JAGEMANN PLATING COMPANY
1324 S. 26TH STREET
MANITOWOC, WI
VAPOR INTRUSION MAP

FIGURE B.4.a

Subject: Please Review for Vapor/Air Investigation: Jagemann Plating Co Inc, BRRTS # 02-36-555544

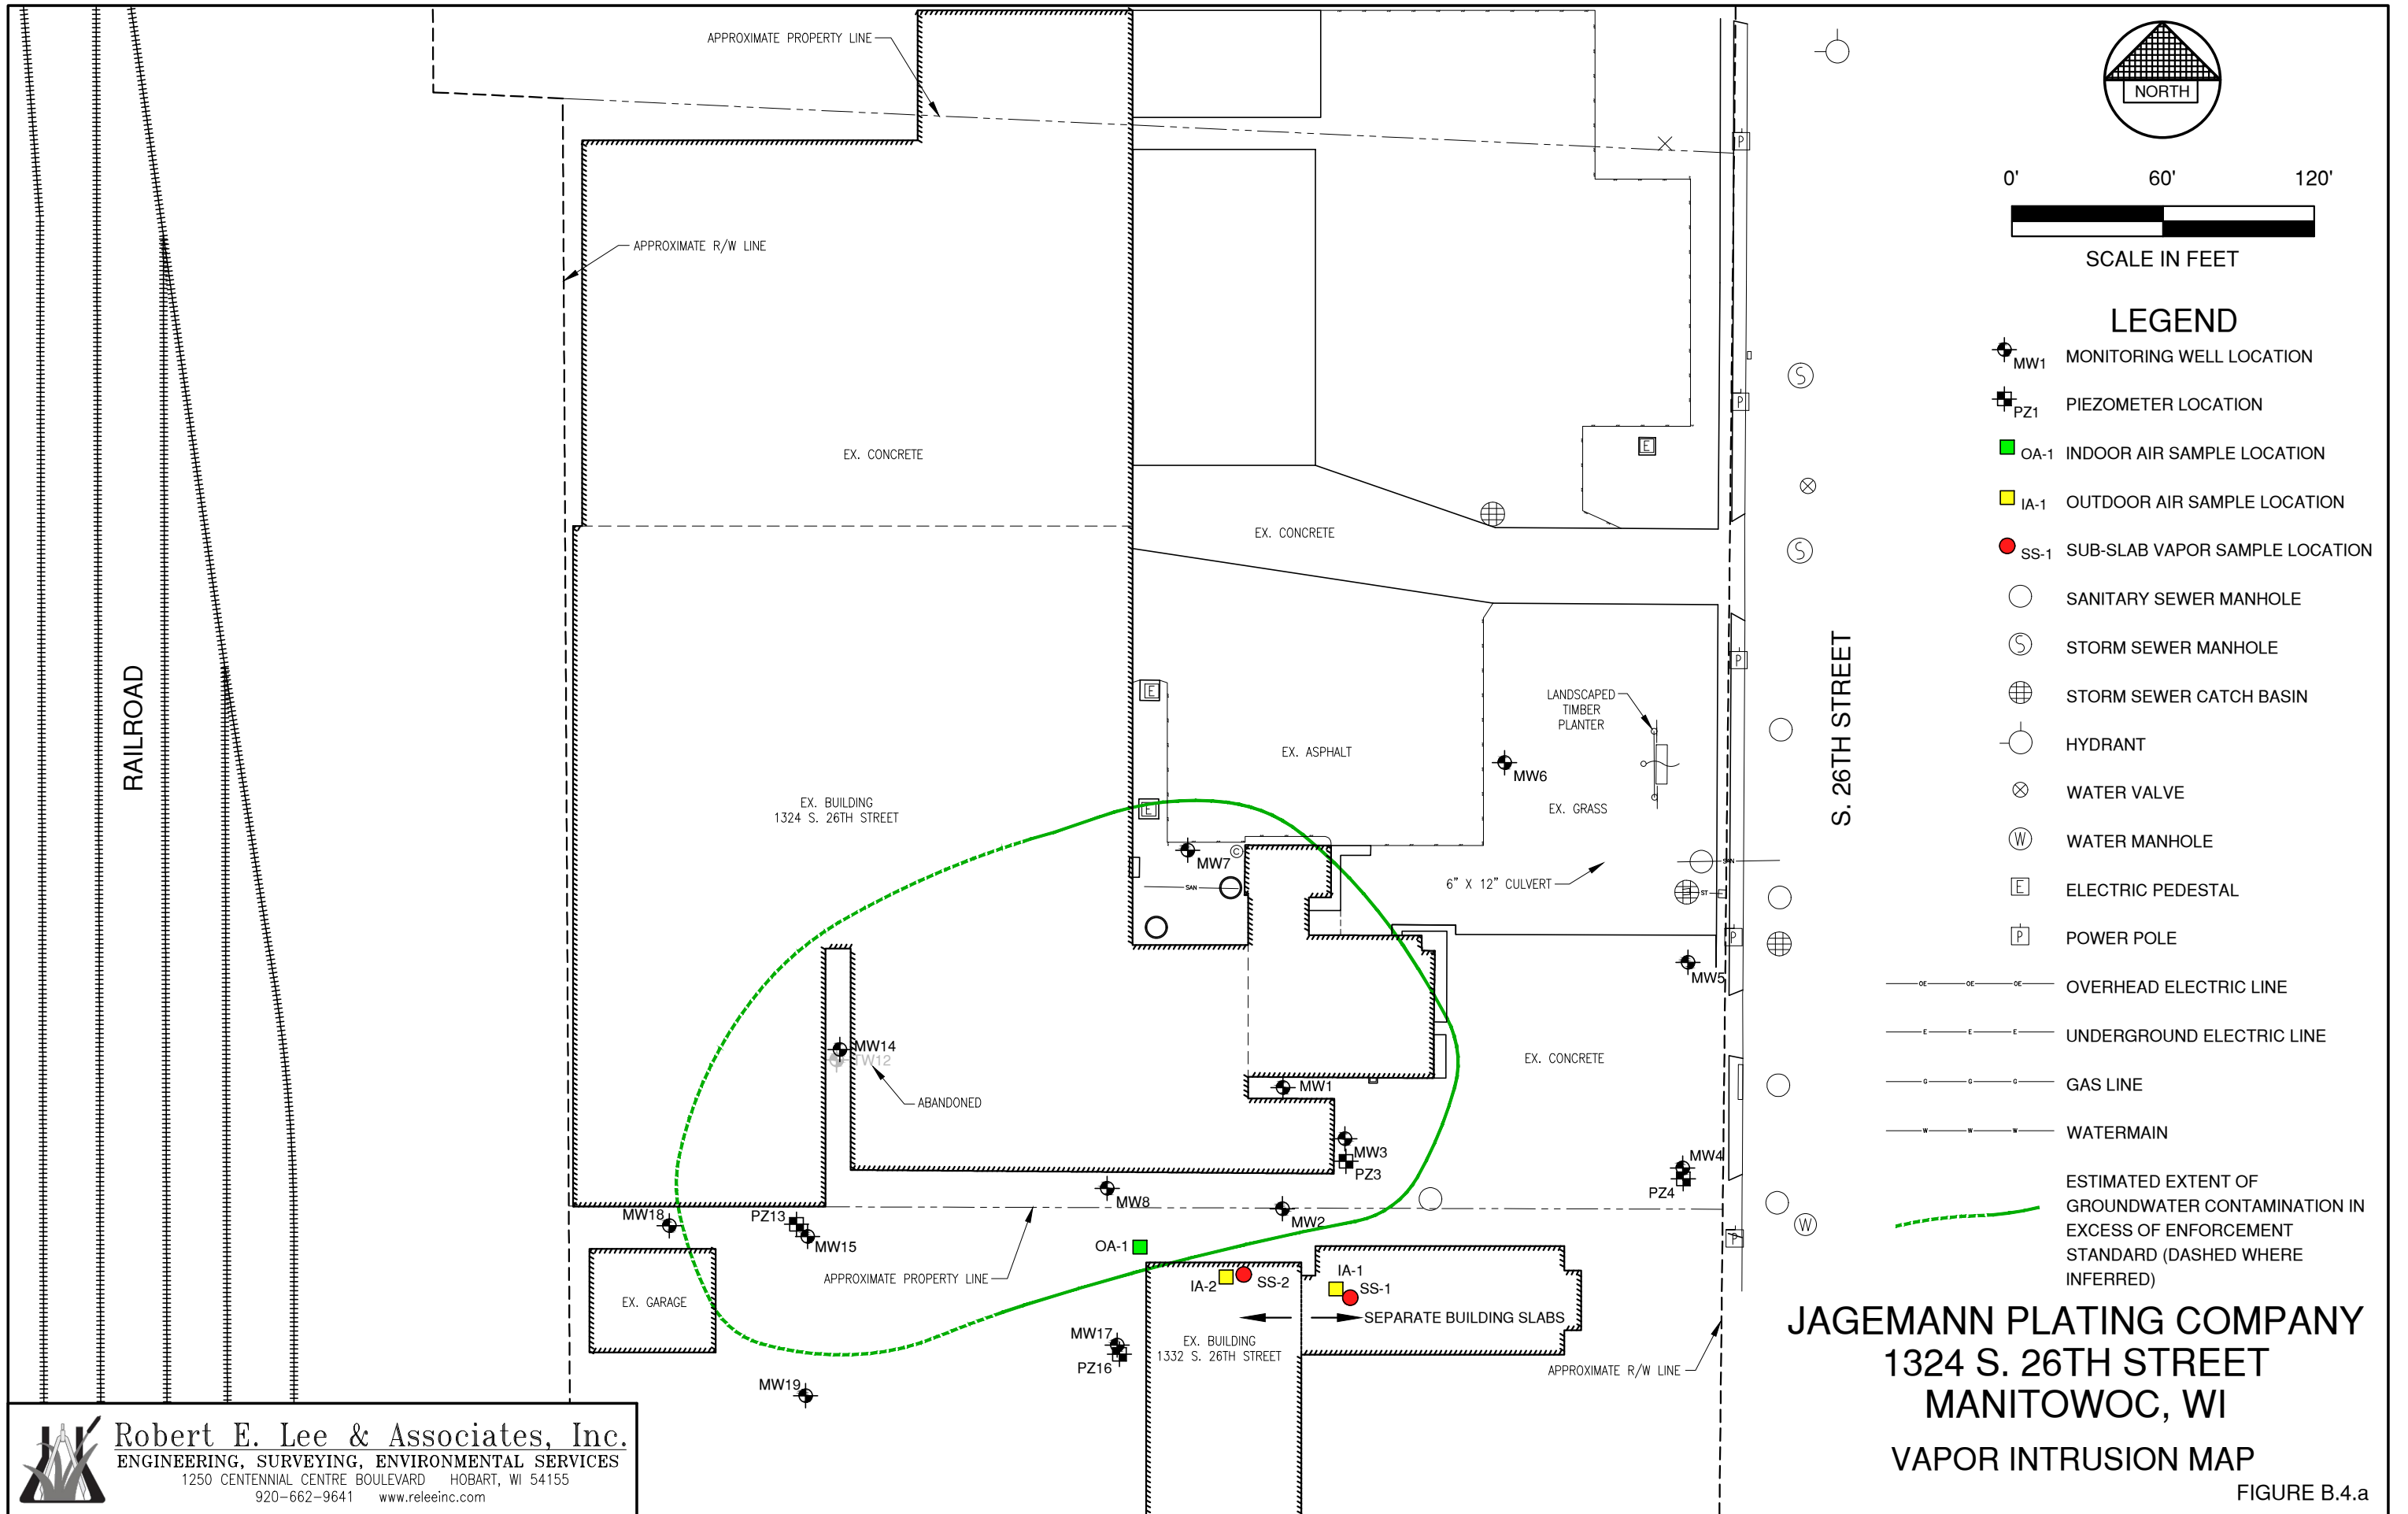
- Enhance the off-site SSV/IA vapor investigation based on interior utility laterals, interior layout & building use.

Mike and I were thinking this statement refers to the work we did in the adjacent building to the south at 1332 S. 26th Street. I attached a map for your reference. Can you confirm that is what she is suggesting by this statement? (she specifically references "interior layout & building use". (We noted during our discussion that both rounds of testing we did for vapor and indoor air had no detects above VAL/VRSL standards.)

- Enhance the off-site SSV/IA vapor investigation based on interior utility laterals, interior layout & building use.
